Re: New York Methodist Hospital
Center for Community Health
505-525 6th Street (Block 1084,
Lots 25, 26, 28, 39-44, 46, 48,
50-59, 164, 1001, and 1002)
BSA Cal. No. 289-13-BZ

We are submitting this letter in connection with the application by New York Methodist Hospital ("NYM" or the "Hospital") for a variance to facilitate the development of a new ambulatory care facility (the "Center") Hospital's main campus in Brooklyn. This letter and the attached materials provide responses to questions asked by the Board at the February 11, 2014, public hearing on the application, as set forth below.

Equipment Screen Study

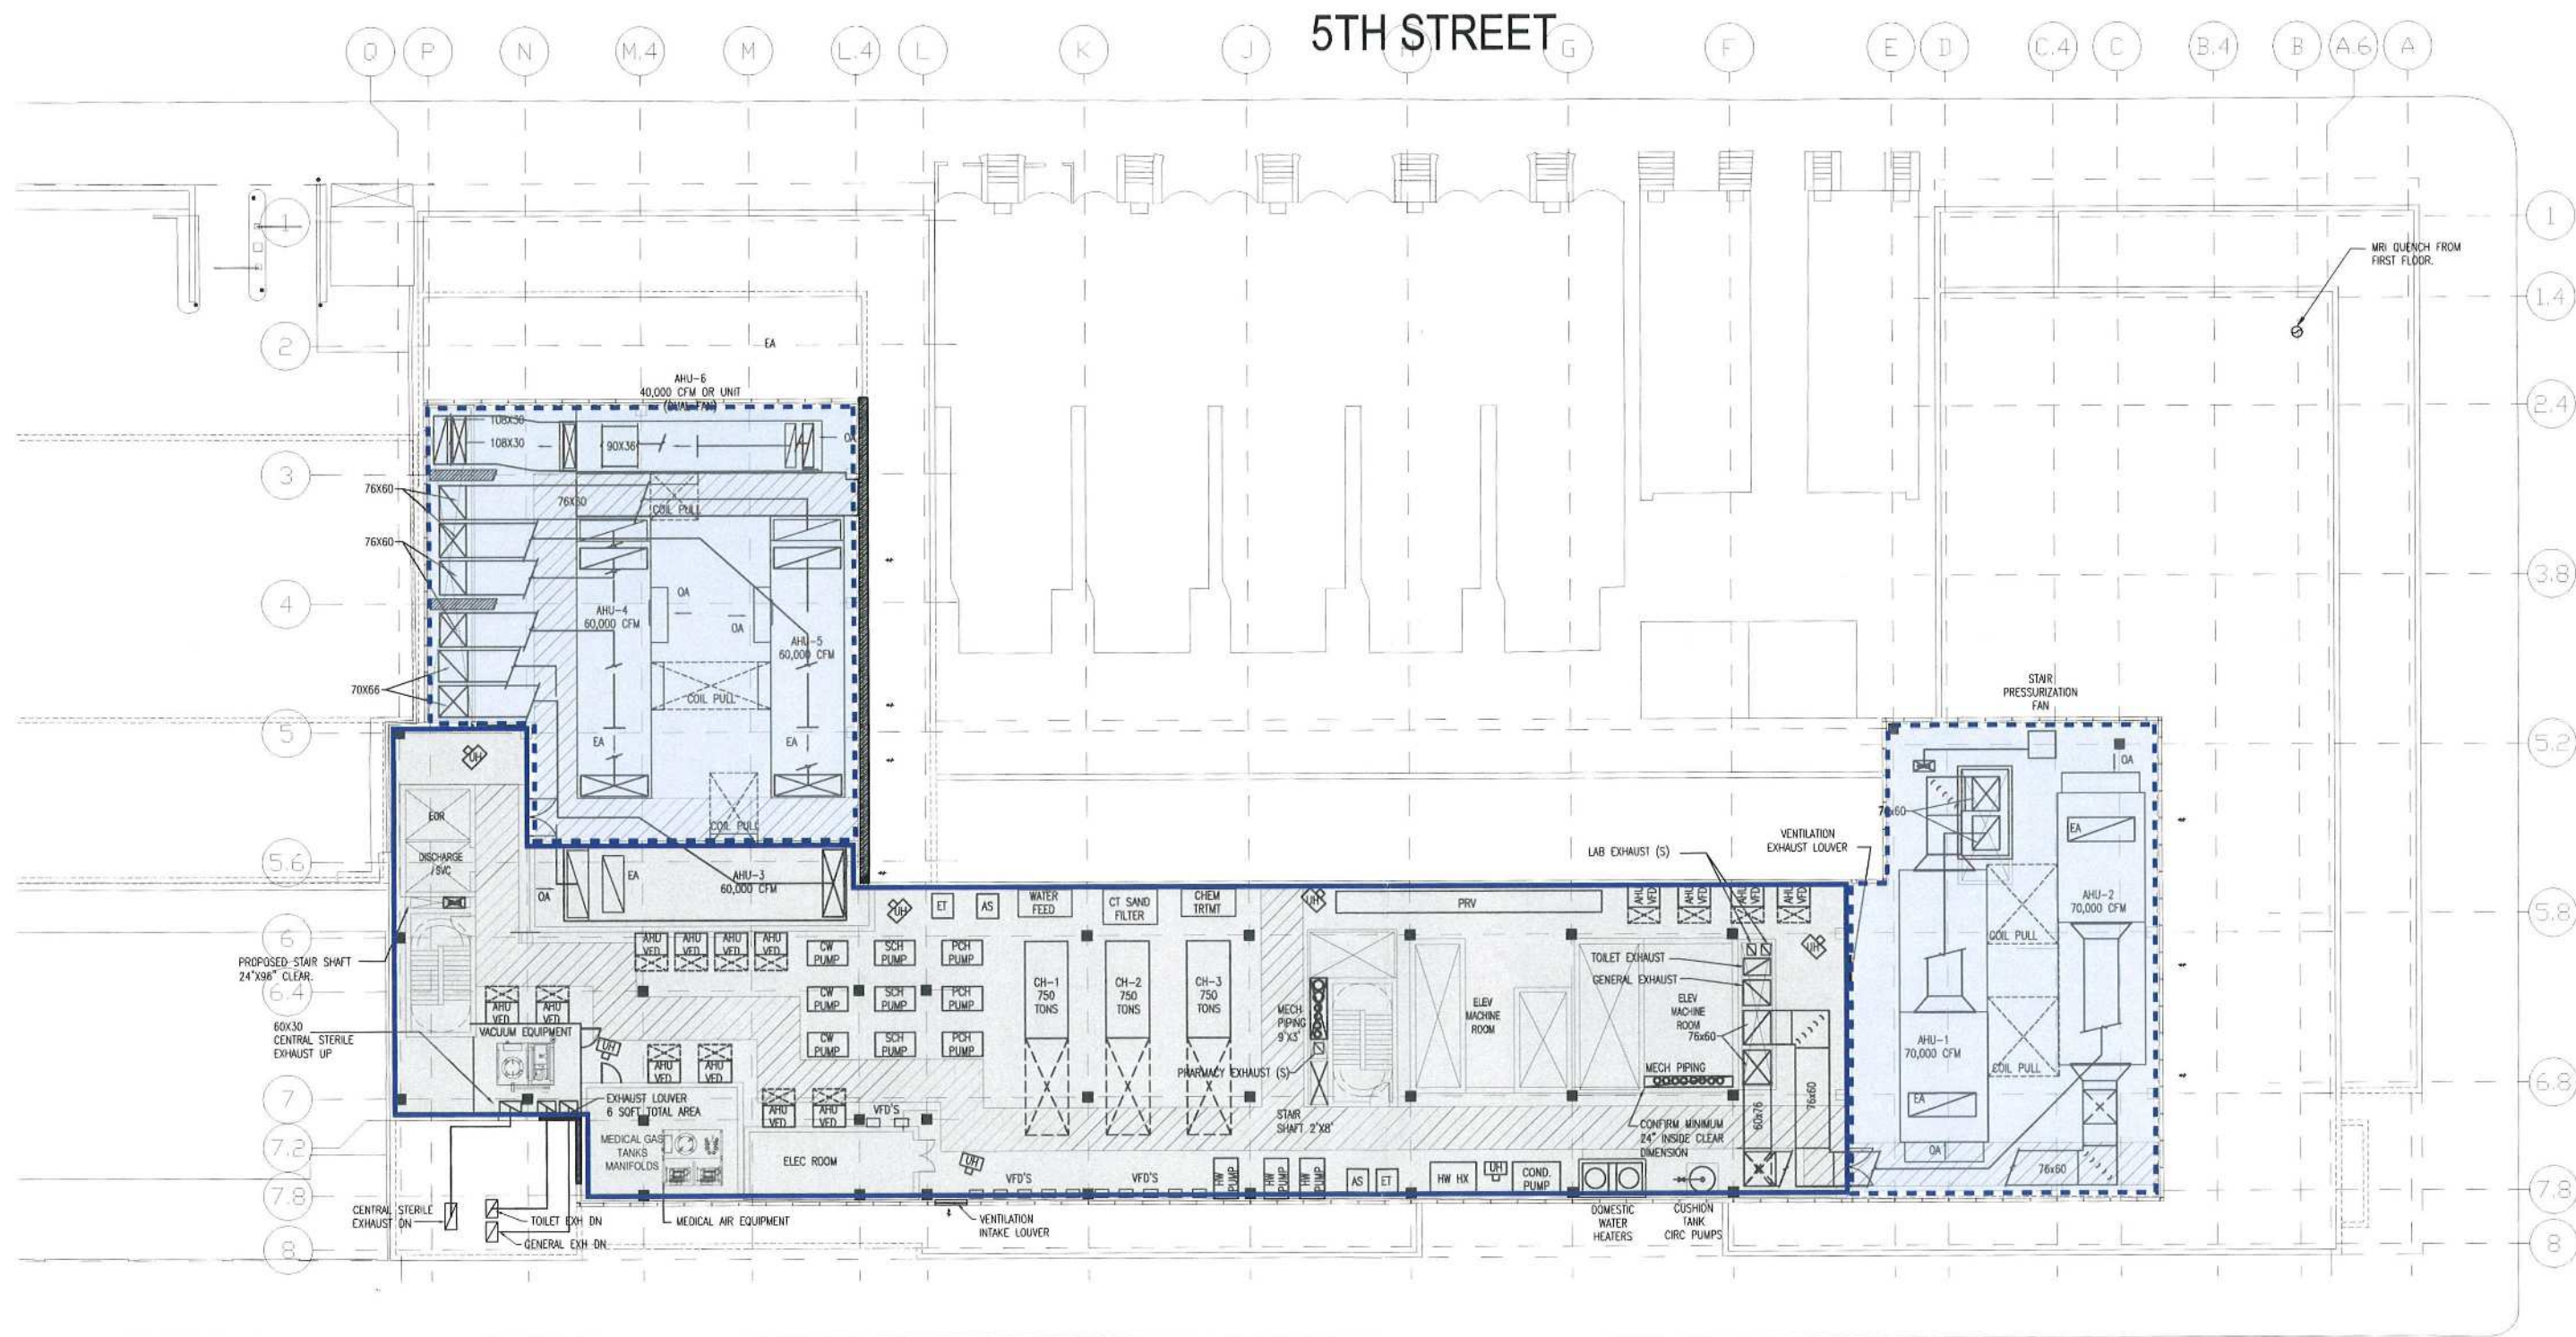
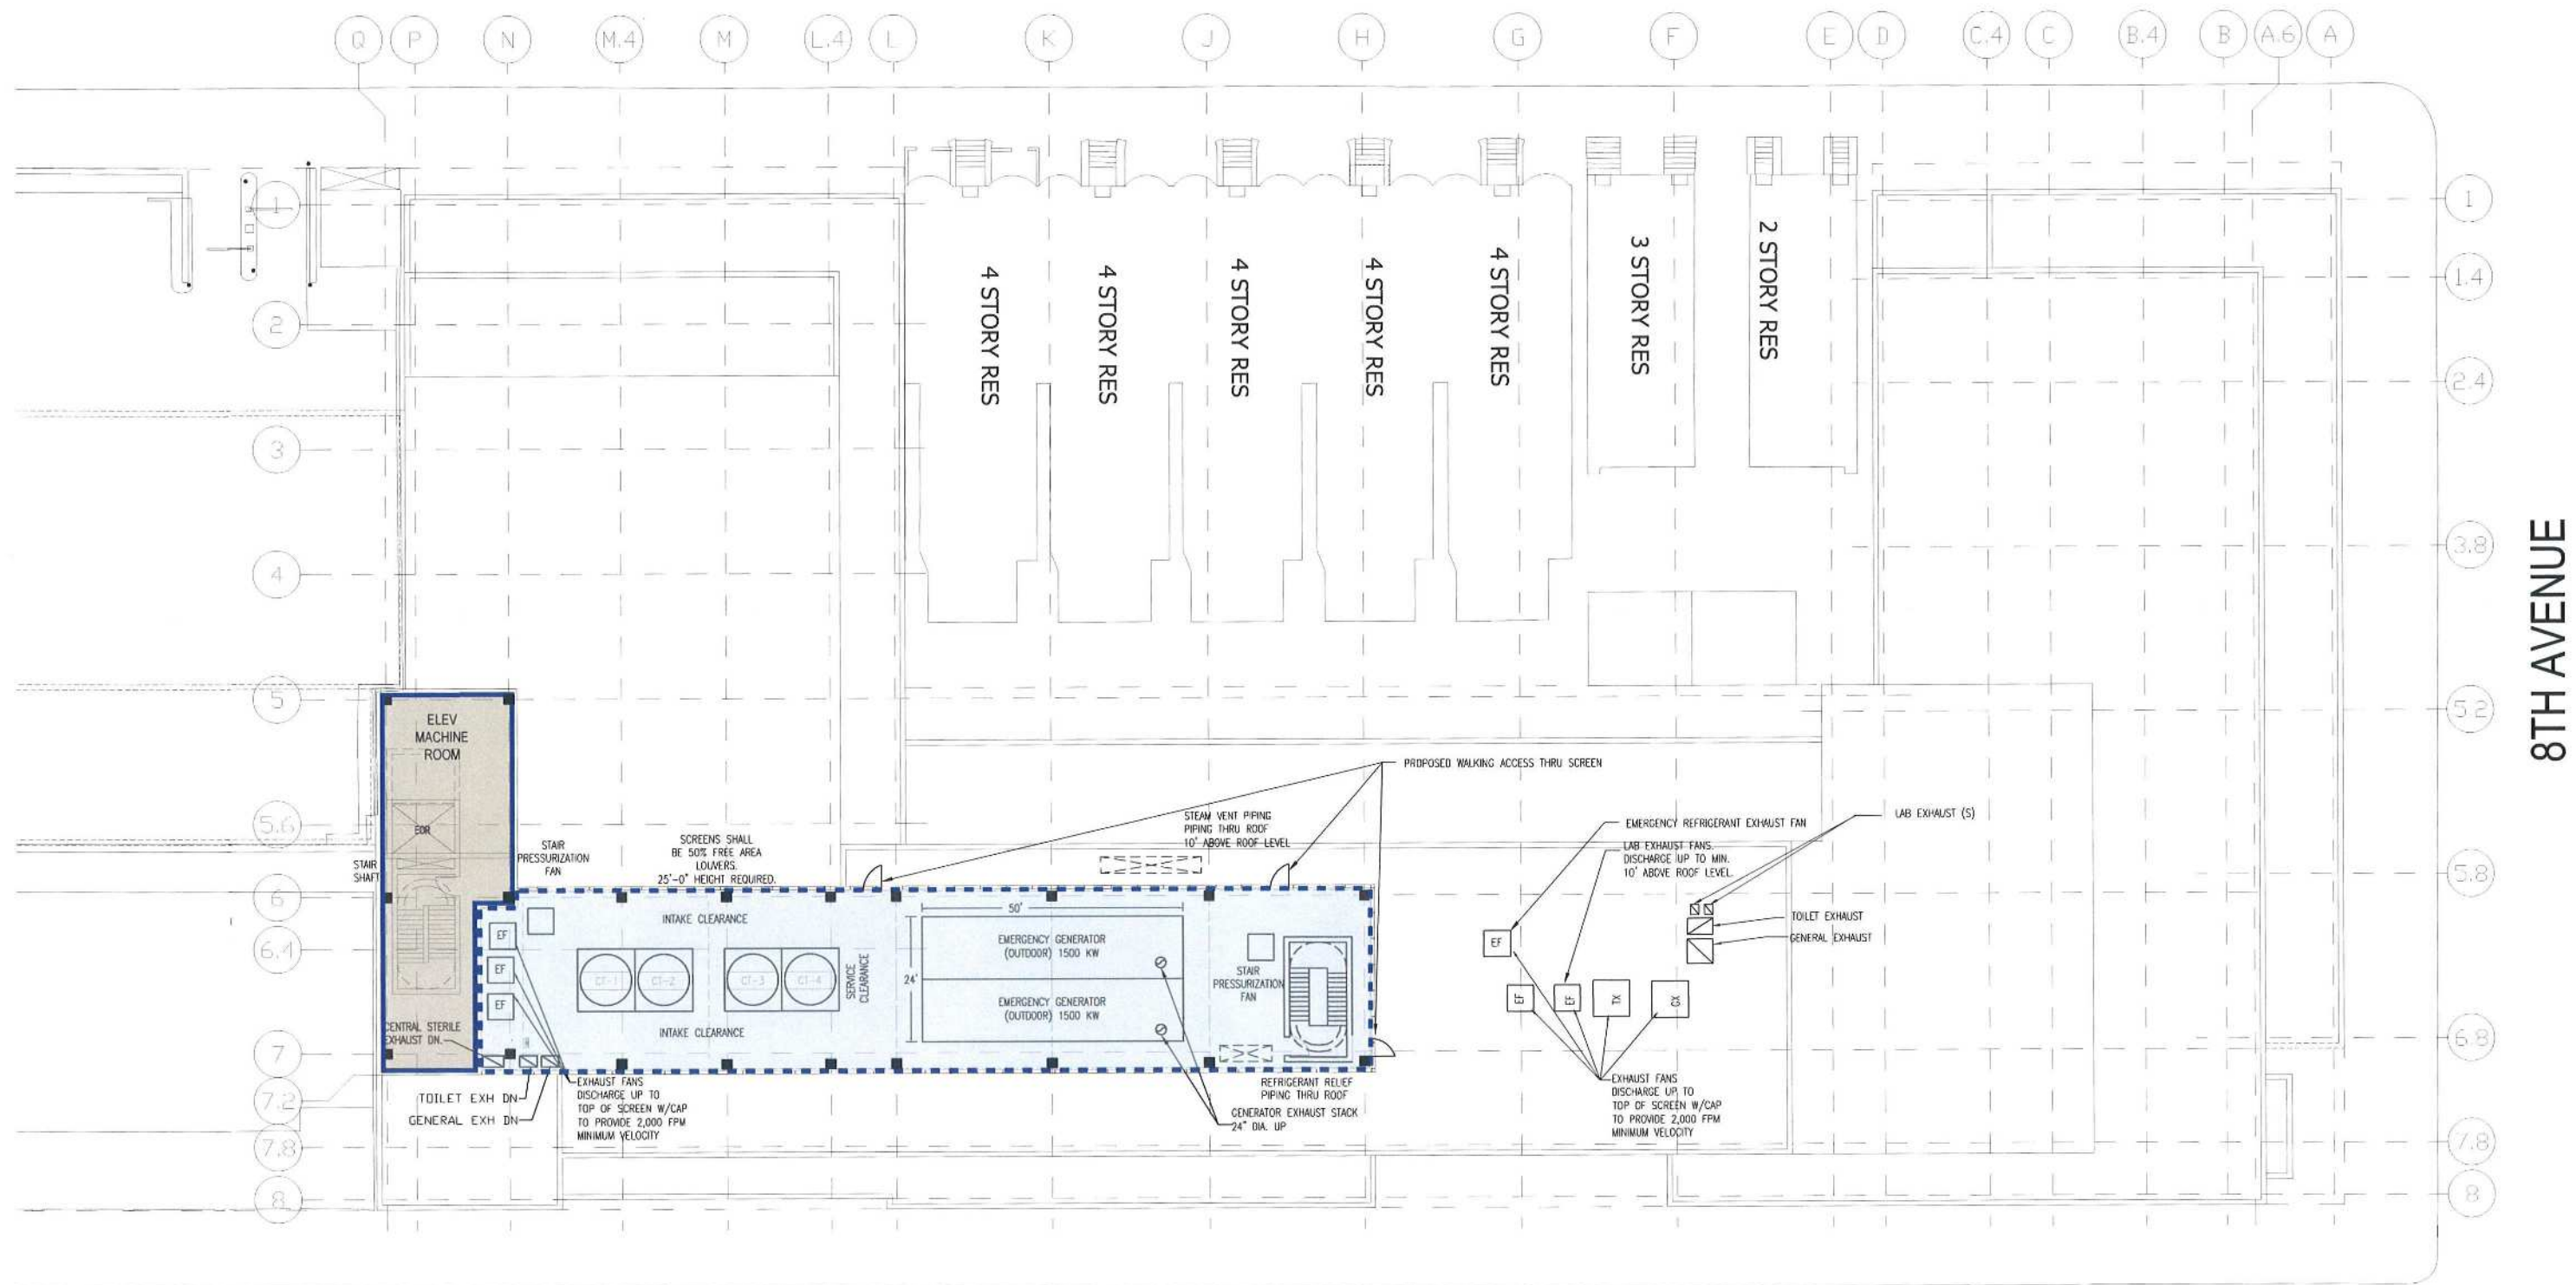
4. *Discuss whether the proposed rooftop mechanical enclosures can be set back farther from 5th Street.*

As shown in the attached Equipment Screen Study, consisting of an 8th Floor Plan Diagram, 9th Floor Plan Diagram, and Section Diagrams, the rooftop mechanical closures for the proposed Center have been designed to provide the minimum required clearance around the rooftop equipment currently planned for the building. They cannot be set back farther from the street for this reason. As the design of the building advances, we will explore options for the mechanical equipment that may require smaller enclosures.
